Central Bedfordshire Council

TRAFFIC MANAGEMENT MEETING

A00150 - The Green, Clophill - One-way working

The Green, Clophill – One Way Proposal

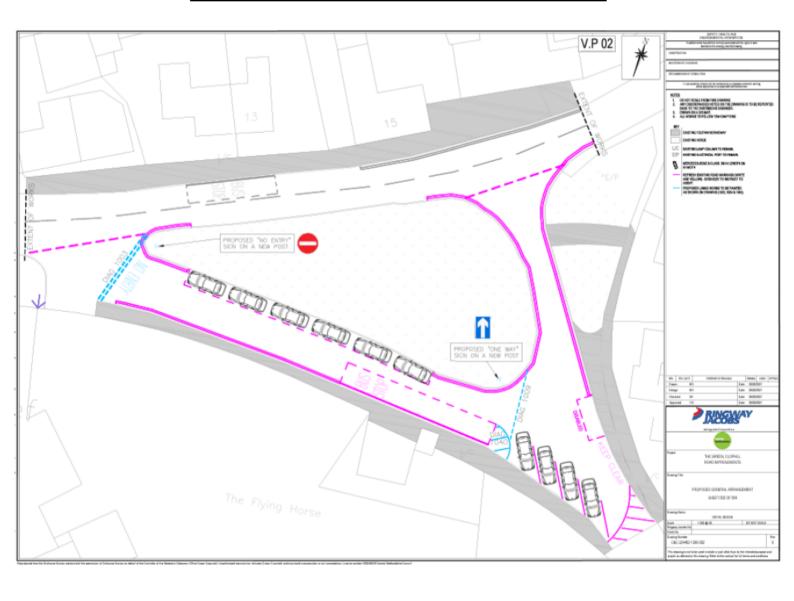
- . There are currently 5 marked parking spaces. The scheme proposes a reduction to 4. This is not acceptable bearing in mind the current congestion that already exists and the reason for it.

- . The loss of one space is to the proposed insertion of hatching to deter parking on or close to the bus stop. We suggest the bus stop should be moved a few metres towards the Flying Horse PH leaving enough space for 5 car parking spaces.

- . The proposed bay angle to the kerb is more acute than at present. This will make it more difficult to reverse than at present in order to follow the proposed one way direction. If the bays remain at their current angle 5 cars can still be parked.

- The current 'disabled' parking bay outside the shop does not comply with current design standards for disabled parking bays. The bay is often occupied by non-Blue Badge holding drivers and is an obstruction to vehicles reversing out of the main parking bays when it is occupied. This should either be:

- o 1. Removed entirely
 - o 2. Moved into the corner adjacent to the patch leading to the footbridge over the A507 (where there is current nondescript hatching

- o 3. Upgraded in accordance with current current standards.

- 13. Following the support received it is recommended that the one-way system is installed as advertised.
- 14. The scheme will be slightly amended so the layout of the existing 5 bays will remain in place and the bus stop will be slightly shortened to accommodate and maintain the existing level of parking.
- 15. Officers will review the position and extent of the existing Disabled Person Parking Bays. Any amendments to this bay will require a further statutory consultation to be

26. It is recommended that the One-way working is installed as advertised with the above amendment to maintain 5 existing limited stay parking bays and shorten the bus stop.
